Technical Memorandum

SUBJECT: Review of L. Wiese Moore LLC Simsboro Aquifer Evaluation Report

DATE: September 1, 2023

Figure 2. AGS This Analytical Simulated Drawdown After Proposed L. Wiese Moore LLC Pumping of 4,452 ac-ft/yr for 10-Years

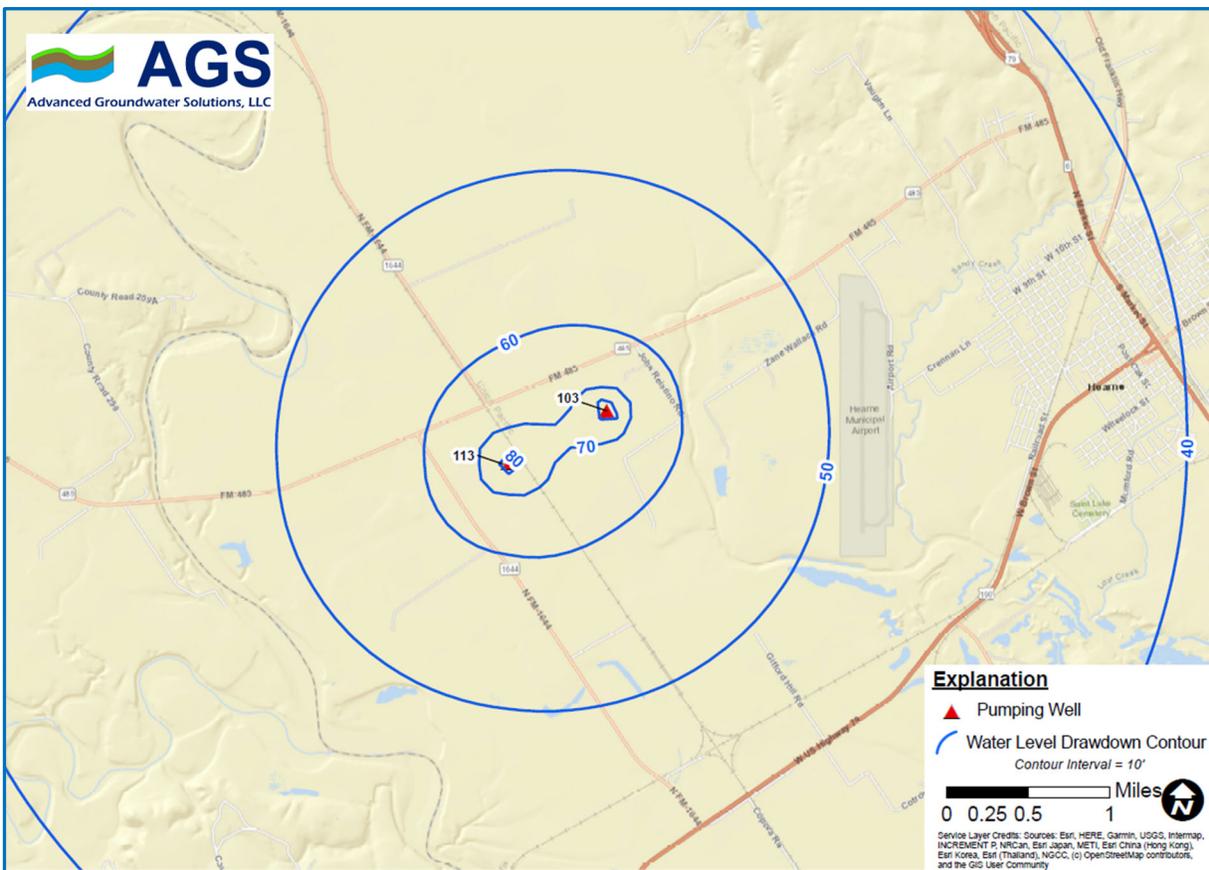
AGS was able to generally recreate the 1-year simulation results of the TGI analytical modeling. The TGI 10-year analytical simulation appears to underestimate the drawdown compared to simulations performed by AGS using the aquifer parameters as described above. Simulated drawdown could be less if TGI used a larger storage value in the 10-year simulation. Figure 2 below shows the estimated AGS analytical modeling drawdown contours that result from pumping 4,452 ac-ft/yr for 10-years.

AGS analytical simulated drawdown at 1-foot from proposed Wiese Moore Wells 1 and 2 is about 90 and 99 feet, respectively after 1-year of pumping and about 103 and 113 feet after 10 years of pumping.

Figure 3. Projected GMA 12 2021 Planning Cycle DFC Water Level Decline at the Proposed L. Wiese Moore LLC Wells.

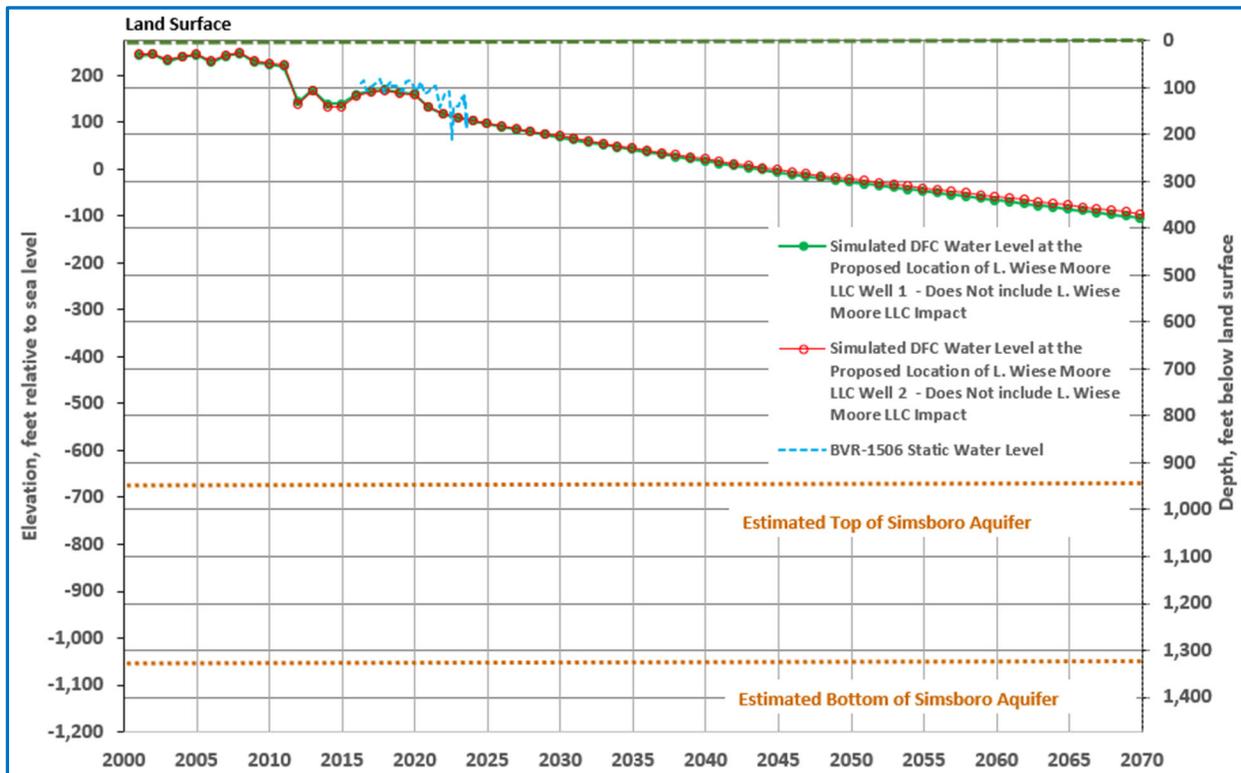
As a way of evaluating potential long-term estimated water level decline at the proposed Wiese Moore wells, AGS plotted the simulated water level decline at each well location based on the 2021 GMA 12 DFC/Modeled Available Groundwater (MAG) projections for the Simsboro Aquifer as shown on Figure 3 below. The water level projections shown in the attached figures are from the TWDB approved DFC/MAG run known as GMA 12 “S-19”, but do not include the local impacts from the proposed Wiese Moore wells included in the AER, nor do they include all of the pumping from the Simsboro Aquifer that has been permitted in the area in the past year. The DFC run includes pumping estimates from the Groundwater Conservation Districts in GMA 12 as of about December 2021 that yield DFCs so that the TWDB can estimate the MAG. The detailed assumptions for the DFC simulation can be found in the GMA 12 Explanatory Report (Daniel B. Stephens & Associates and others, 2022) and documentation of the TWDB MAG run can be found in GAM Run 21-017 MAG: Modeled Available Groundwater for the Aquifers in Groundwater Management Area 12 (Shi and Harding, 2022).

Water levels available from a private domestic well (BVGCD BVR-1506) are shown on Figure 3. The well screen sands of the Simsboro Aquifer and the total depth of the well is 1,250 feet bls. BVR-1506 is located about 0.6 miles west-northwest of proposed Wiese Moore Well 2.

Available drawdown in wells in the Simsboro Aquifer will decline over time based on the DFC simulation. In other words, the lines with green dots and red dots do not include the impact of the proposed Wiese Moore wells. Although not evaluated or discussed in detail herein, these levels of water level decline in wells and artesian head decline in the aquifer will have some impact on vertical leakage, intercepted discharge, reduction in confined and unconfined storage, and potential flow directions in the aquifer. Pumping by the proposed wells will have some of the same type effects on the aquifer.

Figure 8: 1-Year GAM Drawdown Contours

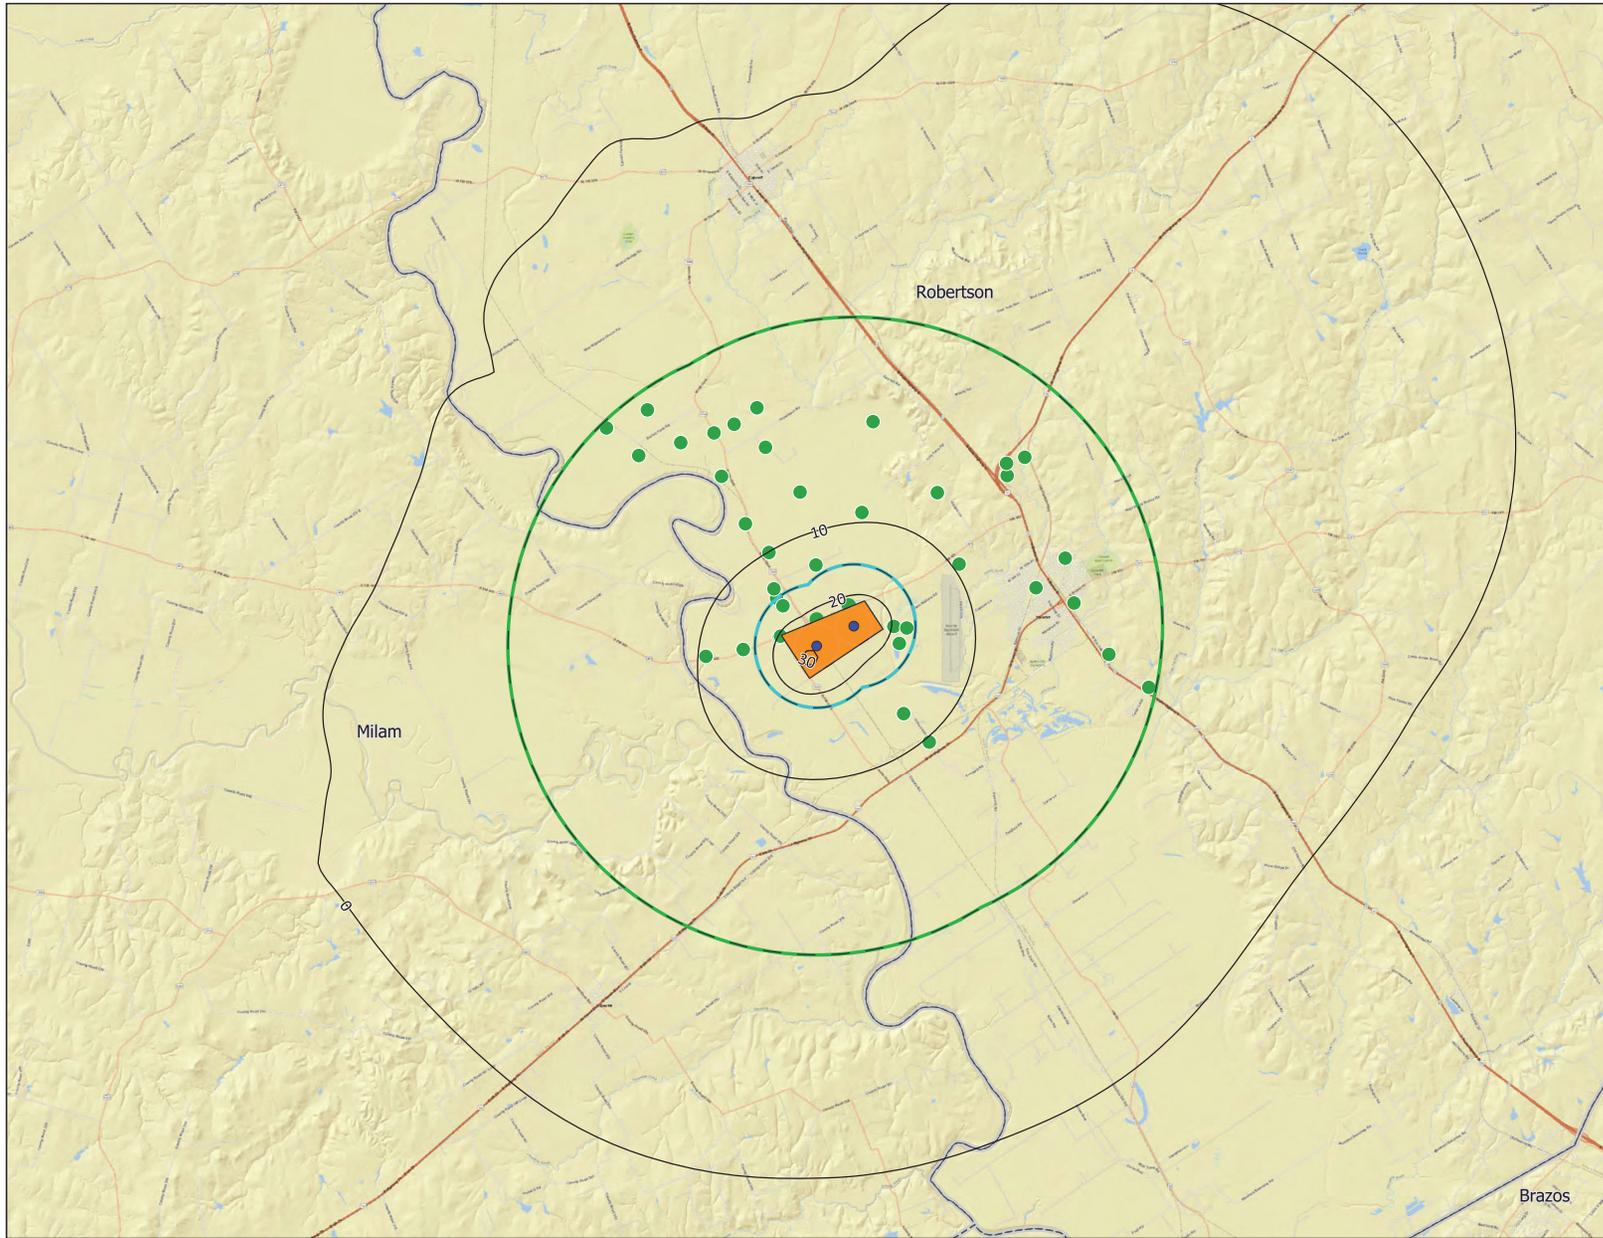
TGI used the TWDB Central Portion of the Sparta, Queen City and Carrizo-Wilcox Aquifer GAM to estimate drawdown that results from continuously pumping the proposed Wiese Moore wells at a combined rate of 4,452 ac-ft/yr for 1 year and 10 years. A copy of the TGI 1-year and 10-year GAM simulated interference drawdown illustrations from the AER (TGI Figures 8 and 9) are attached to this memorandum. Tables 1 and 2 in the TGI AER shows GAM simulated 1-year and 10-year drawdown estimates at most BVGCD permitted and registered Simsboro wells within a 1-mile and 5-mile radius of the proposed Wiese Moore wells. The TGI report did not discuss the GAM simulation methodology, but the TGI GAM model results appear to be reasonable based on AGS simulation verification runs.

The AGS GAM simulation results after 1 and 10 years of pumping 4,452 ac-ft/yr show about 10 feet or less of drawdown at 5 miles and about 20 to 23 feet of drawdown at 1 mile after 1-year of pumping and about 5 to 15 feet of drawdown at 5 miles and about 23 to 25 feet of drawdown at 1 mile after 10-years of pumping. The AGS GAM simulations show slightly higher simulated drawdown than the TGI simulations, however the estimated drawdown in each simulation are within about 10 feet.

The GAM estimated drawdown contours near proposed Wiese Moore wells appear to be influenced by faults included in the GAM, which are in the same general area as faults that have been mapped by GWC and AGS using local geophysical logs and other hydrogeologic data.
